Application for Works Approval Amendment

Works Approval Number	W6504/2021/1
Works Approval Holder	Norton Gold Fields Pty Limited
ACN	112 287 797
File Number	DER2021/000023
Premises	Binduli North Minesite Legal description - Mining tenements M26/115, M26/243, M26/387, M26/420, M26/430, M26/445, M26/446, M26/447, M26/468, M26/474, M26/629 and M26/833 As defined by Figure 1 attached to the Revised Works Approval
Date of Report	29 November 2023
Decision	Revised works approval granted

Figure 1: Prescribed premises and site infrastructure

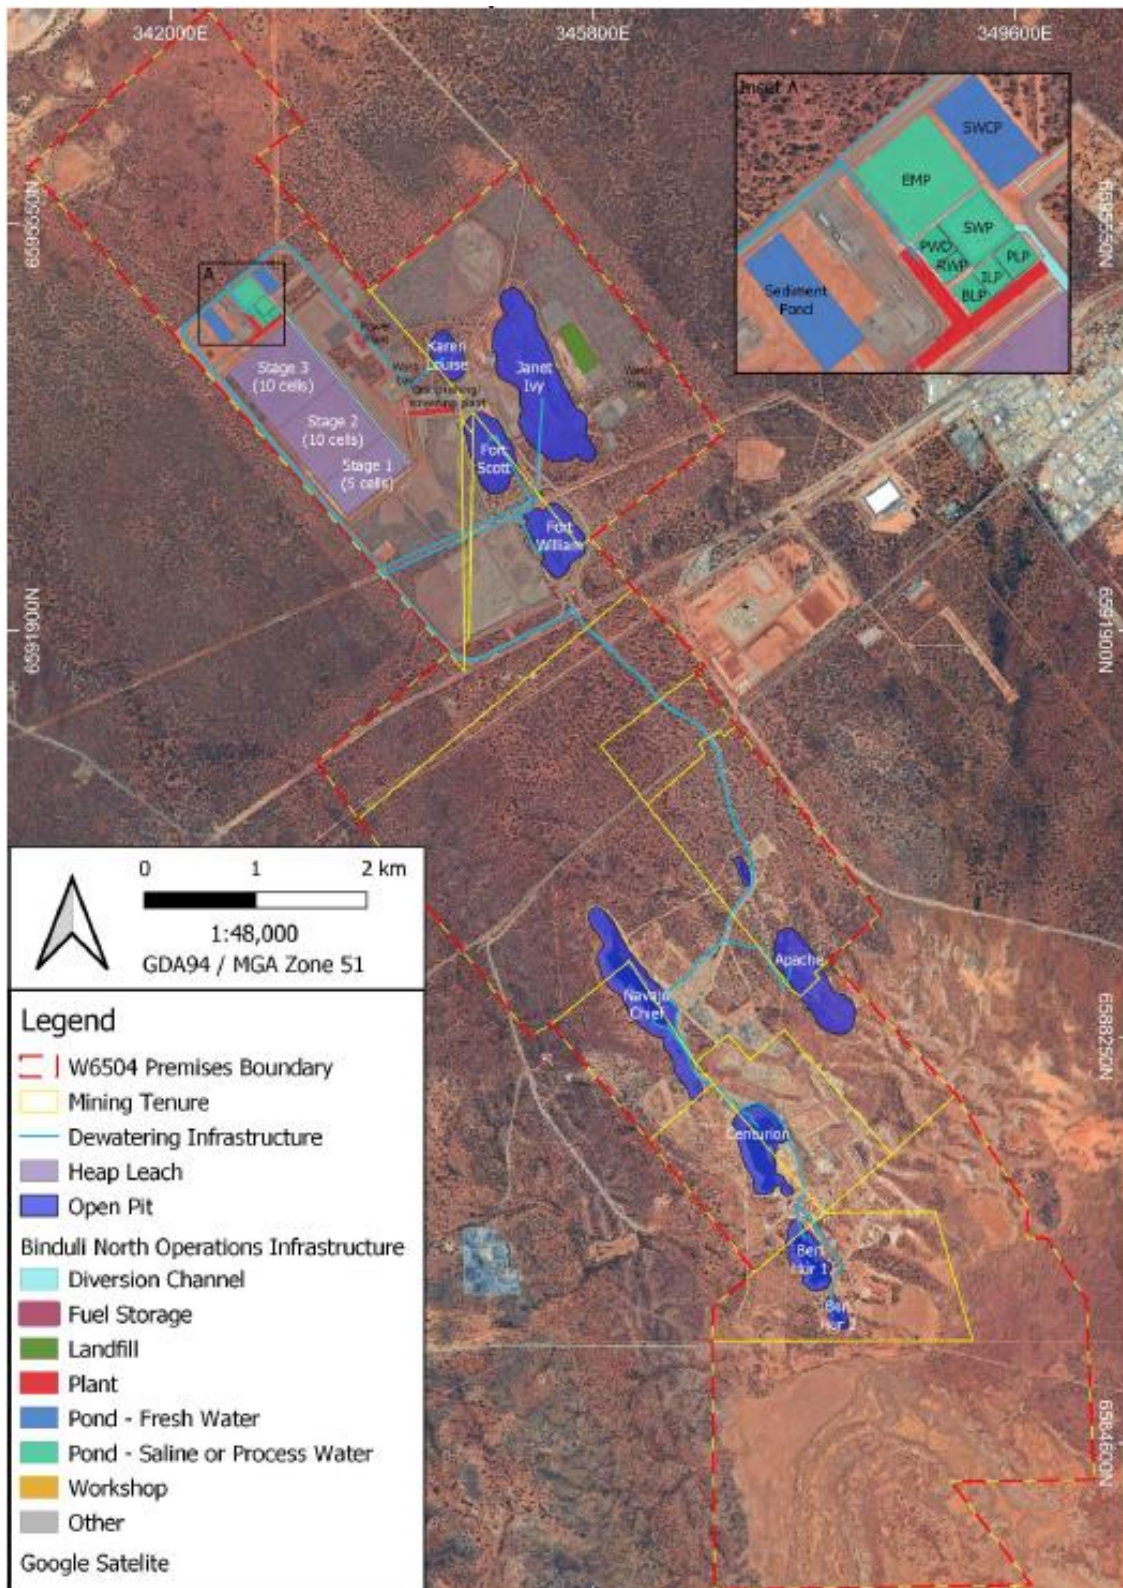
- Expansion of the emergency pond (EMP) from 105,380 m³ to 197,760 m³ and the expansion of the sediment pond from 7,733 m³ to 74,170 m³. The proposed expansion of the ponds is a result of the Works Approval Holder requiring additional clay for the construction of stage 2 Heap Leach Ponds (Figure 1).

- Construction of an additional washdown bay located approximately 800 m east of Janet Ivy pit as presented in Figure 1.

Condition no.	Proposed amendments
Front Page	Amended Premise details description to include reference to figure presenting the prescribed premises boundary.
Condition 1: Item 6	Emergency pond holding capacity amended from 105,380 m ³ to 197,760 m ³ .
	Note added to table 1 to indicate that pipeline routes in Figure 1 are indicative only.
Condition 1: Item 7	Sediment pond holding capacity amended from 7,733 m ³ to 74,170 m ³ .
Condition 1: Item 11	Removed "All pipelines to have leak detection and automatic cut of functions;" and added "All pipeline containing dewater effluent or brine discharge are either: <ul style="list-style-type: none"> a) equipped with telemetry systems and pressure sensors along pipelines to allow the detection of leaks and failures; b) equipped with automatic cut-outs in the event of a pipe failure; or c) provided with secondary containment sufficient to contain any spill for a period equal to the time between routine inspections."

Condition 1: Item 12	Added grammatical correction to add an additional washdown bay to the infrastructure list and reference to Figure 1 for location.

Figure 2: Distance to sensitive receptors

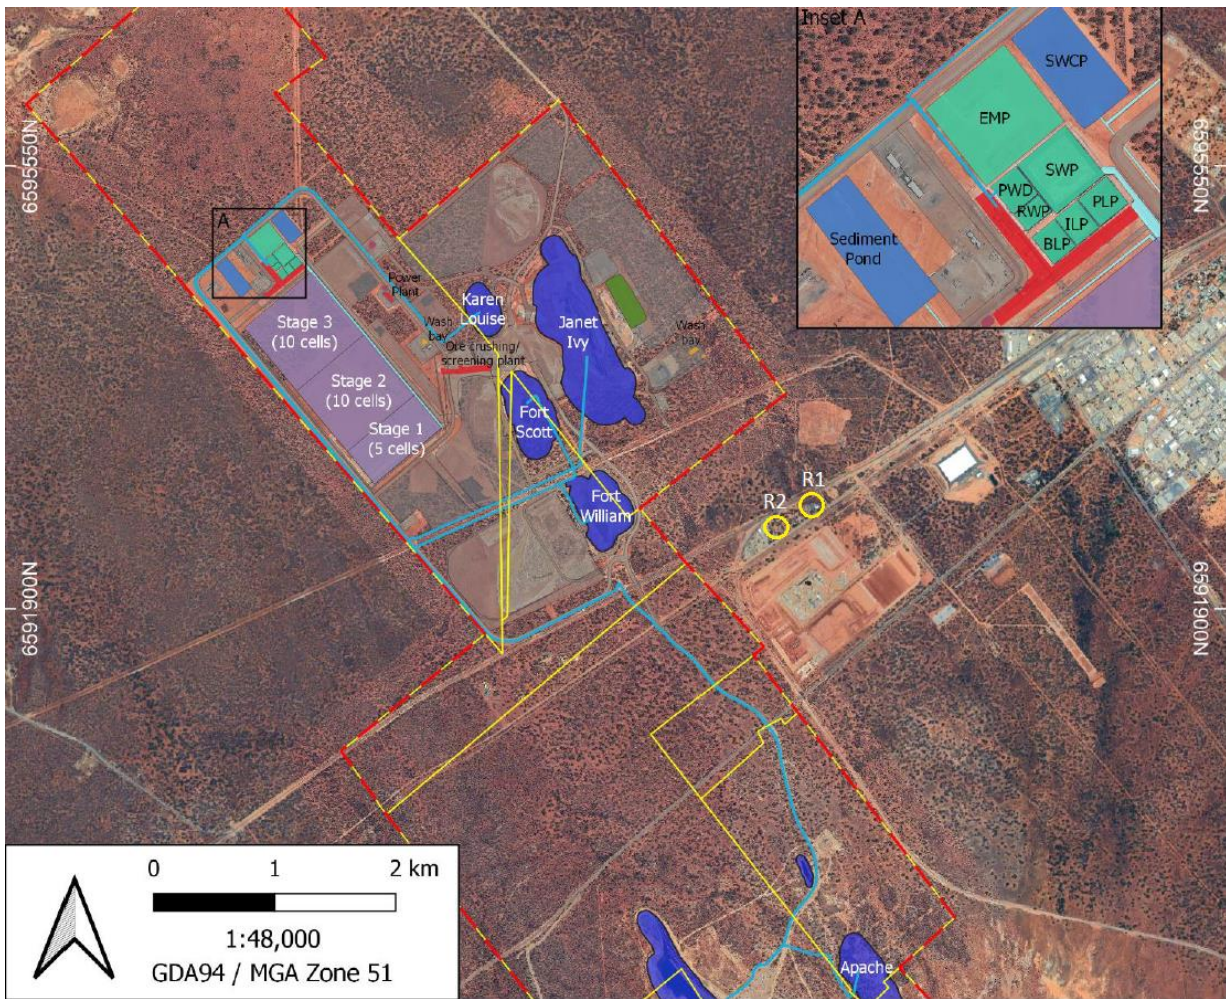
Human receptors	Distance from prescribed activity
Industrial/commercial/residential premises	<p>The nearest industrial/commercial/residential buildings are located approximately 0.6 kms northeast and of the premises.</p> <p>The new proposed washdown bay location is located approximately 1.4 kms northwest of the Industrial/commercial/residential buildings (R1 and R2, Figure 2).</p>
Environmental receptors	Distance from prescribed activity
Native Vegetation (Mixed Eucalyptus woodlands)	<p>Native vegetation appears both within and surrounds the prescribed premises.</p> <ul style="list-style-type: none"> Native vegetation appears approximately 25 m (closer than the original proposed works) northwest (across a road) from the emergency pond and sediment pond. Scattered vegetation is present to the north and west of the proposed Apache pit. (Apache pit will be located amongst other pits nearby). Native vegetation is also present near the

additional proposed (eastern most) wash bay approximately 10 m away.
Surface water lines and bodies	<p>No bodies of water or water lines appear to be present amongst the northern portion of the prescribed premises (location of emergency pond and sediment pond). The closest receptor is an ephemeral body of water that is located approximately 1.5 km northwest of the emergency pond.</p> <p>Proposed Apache pit (at the southern portion of the prescribed premises) appears to have ephemeral water lines running through it into a non-perennial lake located approximately 350 m southeast of Apache.</p>
Priority or Threatened Flora (Screened out)	<p>Priority and threatened flora were identified nearby the prescribed premises. Nearby identified priority and threatened flora are presented below:</p> <ul style="list-style-type: none"> • P2 flora species is located approximately 3 to 6 kms from the proposed wash bay at the eastern portion of the prescribed premise. The sightings were recorded between 1994 and 2000. • P3 flora was identified approximately 3 kms from the proposed Apache pit. The siting was in 1993. • P2 flora was identified approximately 3.5 to 4.5 kms from the proposed Apache pit. Recordings ranged between 1994 and 2005. <p>No other priority or threatened flora was identified within 5 km of the prescribed premises boundary.</p> <p>Due to the distance from the activities, priority and threatened flora are not considered as a receptor.</p>
